Access Compliance Report

Public Rights-of-Way

(Curb Ramps)

Intersection ID: 16357	Main Street: MONROE_RD	Cross Street: ROSS_MOORE_AV	Location: SE
ADA ID: 71D1C0B495FA	Ramp Type: BlendTrans1	Initial Pass/Fail: Fail	Overall Compliance: No
Severity Score: 8.75			
Codes/Mitigation Info/Possible Solution		Field Measurements/Component Compliance

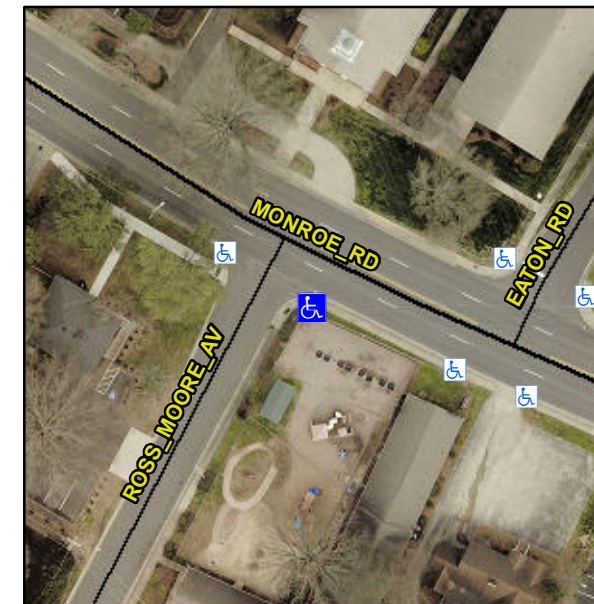
Not Found, R304.5.1

N/A	Ramp inside XWalk1?	N/A	N/A	Ramp inside XWalk2?	N/A
	Road Slope (%)	0.6		Clear Space?	N/A
	Road X Slope (%)	5.4	N/A	Clear Space to XWalk (in)	N/A
N/A	Any Obstructions?	N/A	N/A	Storm Grate/Utility Hazard?	N/A
	Obstruction Type			Storm Grate/Utility Type	
		N/A			N/A
			Yes	Surface Condition? (G/P)	Good
			No	Curb Slope (%)	12.3

Remove & Replace Curb Ramp With Two New Directional Ramps or Equivalent.
